**Lindfield Learning Village Phase 2
and 3**

Transport Response to Submissions

Issue | 22 May 2020

Figure 1: Drop-off / pick-up arrangement and pedestrian route from car parking

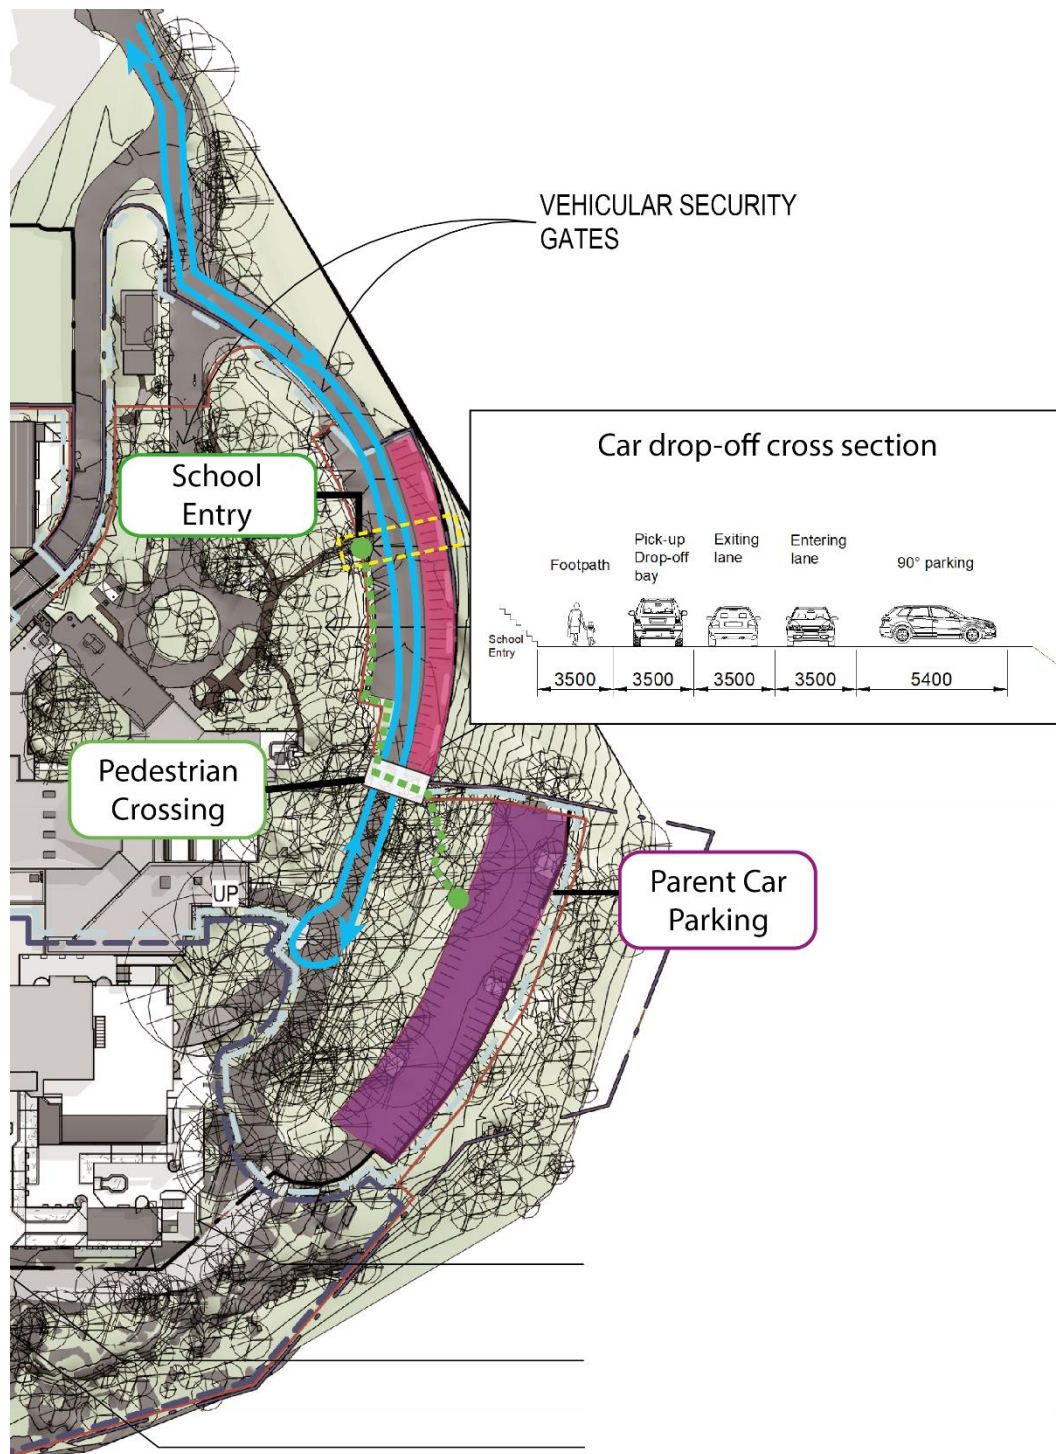
R#	Comment	Arup response
SSD 8114 TTA		
A	Drop-off and pick-up (DOPU) arrangement	
A1	Section 3.1.1 and Figure 2 both indicate that cars would be going along the southbound lane to the roundabout and make a U-turn to access the DOPU lane on the western side in the northbound direction. This presents a two-way traffic operation along this section of the internal road. Clarification is required as the proposed one-way loop would operate around the school site and passes through the proposed DOPU lane during the school DOPU periods, as indicated in Figures 21 and 23.	Section 3.1.1 describes the Phase 1 school operation, which is a two-way operation. The DOPU area operates as in Phase 1, with two passing lanes for either cars or buses or both. This has been explained in a diagram in the response to submissions
A2	Figure 2 shows crossing facilities are not proposed to be provided to allow safe pedestrian crossing, particularly for parents who walk with their children from the car parking spaces on the eastern side to the proposed pedestrian access on the opposite side of the internal road. It is also evident from Figure 2 that a footpath is not provided for pedestrians to access these car parking spaces on the eastern side.	Parents who walk their children after parking are proposed to park in the lower car park and use the path up the hill and pedestrian crossing to walk to the school. The accessible alternative is using the accessible spaces at the top of the school. This has been explained in the response to submissions.

Transport for NSW commented that the explanation of the Phase 1 school required clarification. This section re-presents this information using updated graphics and explanatory text.

Vehicle access to the school and circulation arrangements during Phase 1 is shown in Figure 1. Cars are able approach the school via a two-lane access road from Eton Road, connecting with the east of the school where the two car parking areas as well as the school Drop-off and pick-up area are located.

The access road is two-way in operation and the road continues to the south where a turning head has been installed allowing vehicles to access the lower car park (to an area designated for parents) or make a U-turn back towards the DOPU area.

The DOPU area allows for 10 vehicles to queue at the drop-off / pick-up bay at any one time. This operates with the spaces on the western side converted into parallel car parking bays during the school morning and afternoon peak. These bays then function as parking spaces for visitors, outside of the school peak hours.

Figure 5: Overall layout of the expanded roundabout for buses and new car pick-up road

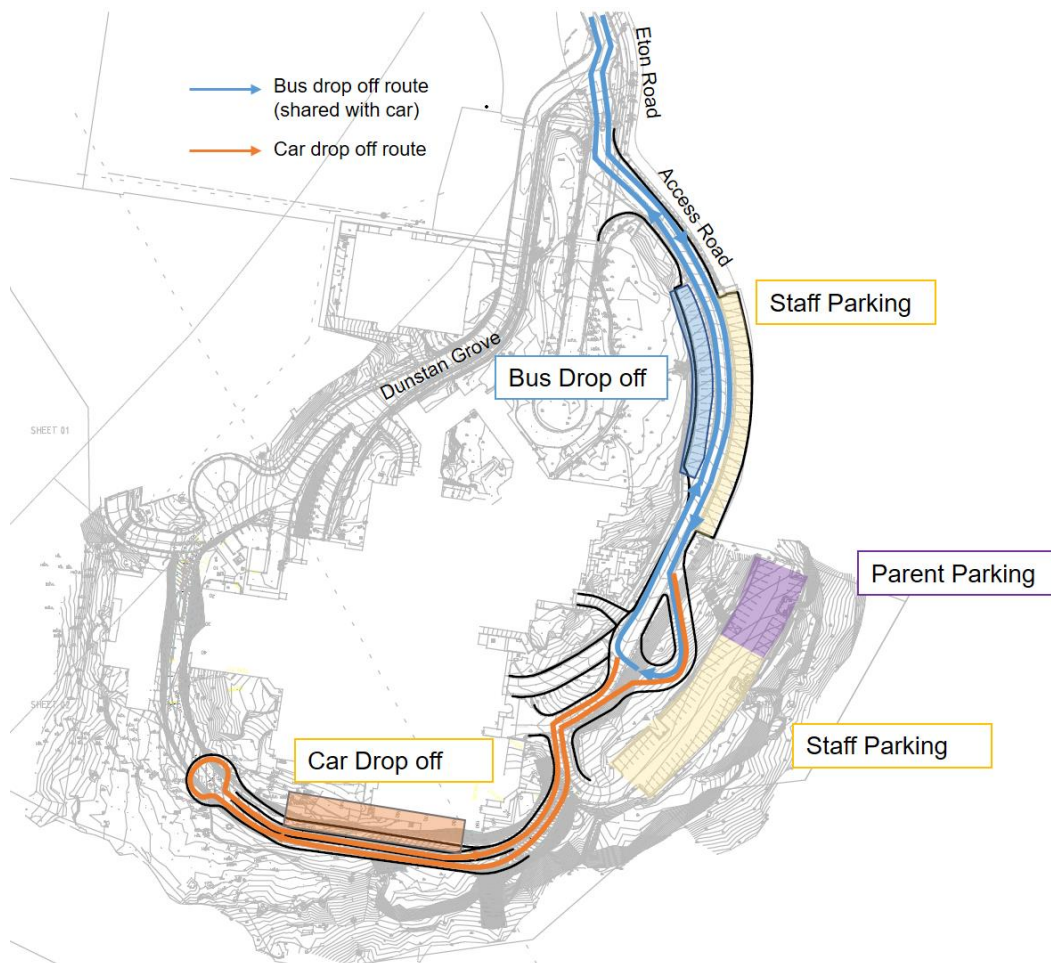
The design team then reviewed the loop road design which included increasing the detail of the design to respond to the safety comments from TfNSW and consideration of the comments received from the road safety auditor. As the design detail increased, it became clear that the loop road option required the extensive widening of Dunstan Grove to provide sufficient width for safe movements for buses, small trucks, cars and pedestrians. This increased substantially the cost and expense of the loop road design and therefore an alternative design was selected to move forward.

The alternative access design consists of expanding the existing car turnaround into a bus turnaround (30m diameter) to enable buses to use the upper car park as bus zone as shown in Figure 5.

The turnaround is shown in Figure 8 and has been designed for a 14.5m coach bus to complete the turnaround. The new bus turnaround would be constructed to cantilever over the topography, to not impact the lower car park.

Figure 8: Bus operations at round about (Phase
2 & 3)

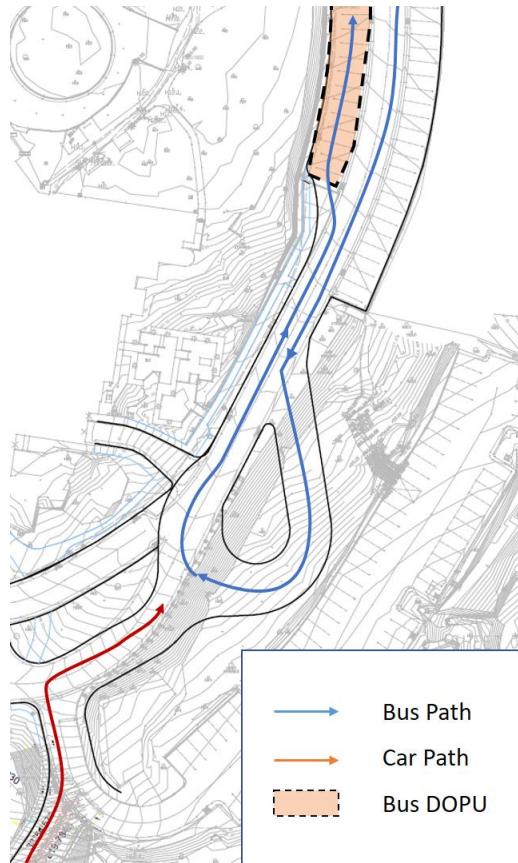
A5	Adequate space for buses to safely pass on the outside lane along the section of loop road where bus DOPU bays and bus queuing bays are located must be provided. In addition, it is strongly recommended to provide road width that is capable of accommodating two buses	The proposed development no longer involves the loop road, with revised car and bus access accommodated within the eastern portion of the site. The bus parking area includes width for two-way operations and the bus bay.

Figure 12: Selected proposed bike routes from Ku-ring-gai Council's 2012 Bike Plan

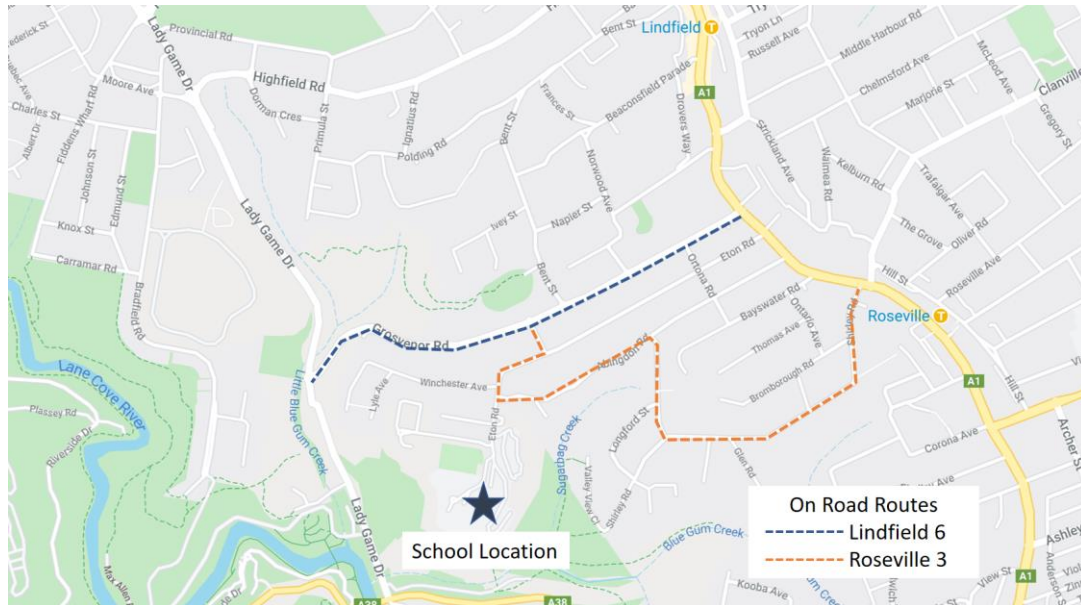
O2	Provision of 2 or 3 safe, separated cycle routes to the Lindfield Learning Village for Phase 3 would give staff a serious alternative to driving and help to achieve the 42% mode share target. As well, it	Separated cycle routes are not recommended in the Ku-ring-gai Bike Plan for implementation near to the site. Staff would be able to ride along the roads as

Ku-ring-gai Council's 2012 Bike Plan proposes several on-road cycle routes as part of their potential future cycling network. From this document, the Lindfield 6 and Roseville 3 proposed sections are the two most relevant routes which connect with the school as indicated in Figure 12.

Figure 17: DOPU area queuing extent

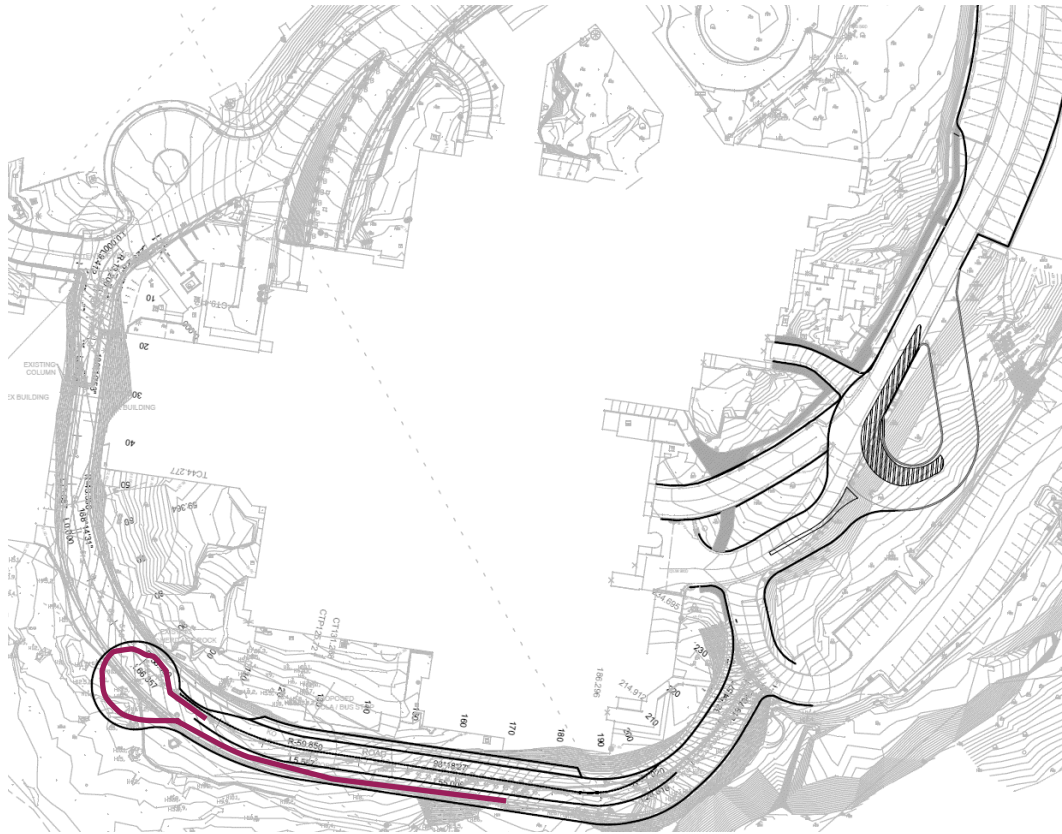
R#	Comment	Arup response
	early for the pickup sessions and there is the potential for queues to form/extend into Dunstan Grove and it is unclear if this tendency to arrive early and queue can be managed by the school. Indeed, if all 134 vehicles arrived and queued prior to the 2.50pm pick-up timeslot under Phase 3, the queue would extend through Dunstan Grove and back to Eton Road. The school would have to demonstrate that the drop-off and pick-up queues can be managed so as not to cause congestion and queuing in Dunstan Grove.	
U	Loop Road	
U1	The proposal to utilise the anti-clockwise bus loop road around the (now) K-12 school campus for private vehicles will increase traffic flows in Dunstan Grove by approximately 241 vehicle trips in the school AM peak and by approximately 179 vehicle trips in the school PM peak. This is a substantial change in traffic flow characteristics and understandably has raised the concerns of residents in Crimson Hill, who have suggested confining school traffic to Eton Road and the current set-down and pick-up area.	Comment no longer relevant. The proposed development no longer involves the loop road for car and bus access.

The expected queue length developed in the morning peak is summarised in Table 8. As can be seen, the queues are 10 cars long or 65m assuming 6.5m per car and the expected queue length developed in the afternoon peak is four cars or 26m. This also shown in the following diagram in Figure 17. The queues developed are not likely reach or interfere with the bus turn around area and impede bus operations.

Figure 22: Construction traffic vehicle routes

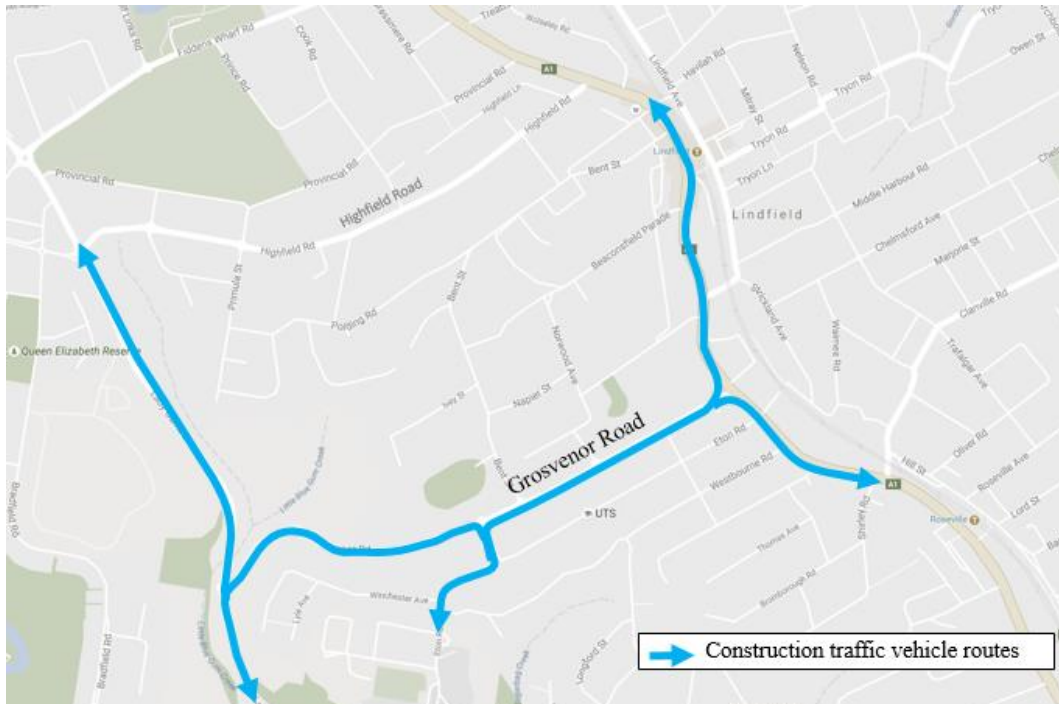
R#	Comment	Arup response
U4	During construction, the driveway opposite Dunstan Grove is designated as the primary access point. Residents of Crimson Hill experienced a number of issues during construction of Phase 1 with construction vehicles stopping in Dunstan Grove and blocking local access and traffic. Stop/slow arrangements were necessary at the time, as the width of Dunstan Grove was inadequate for 2 way traffic flow, confirming the need to undertake localised kerb adjustments to address swept path conflicts early in the process to maintain access to residents.	Noted. The construction traffic management plan outline describes the issues noted in the previous phase and outlines strategies to manage construction traffic on Dunstan Grove.

Vehicular Access to and from the site shall be from Eton Road. The site access gate will be set up at Eton Road southern end where the junction forks to the lower car park. Access to Dunstan Grove and Shout Ridge Road shall be unaffected.

Road Access: The main arterial road to the North East of the site is the Pacific Highway and to the South West is Lady Game Drive, with Grosvenor Road used as the main link road between the two, illustrated in Figure 22.
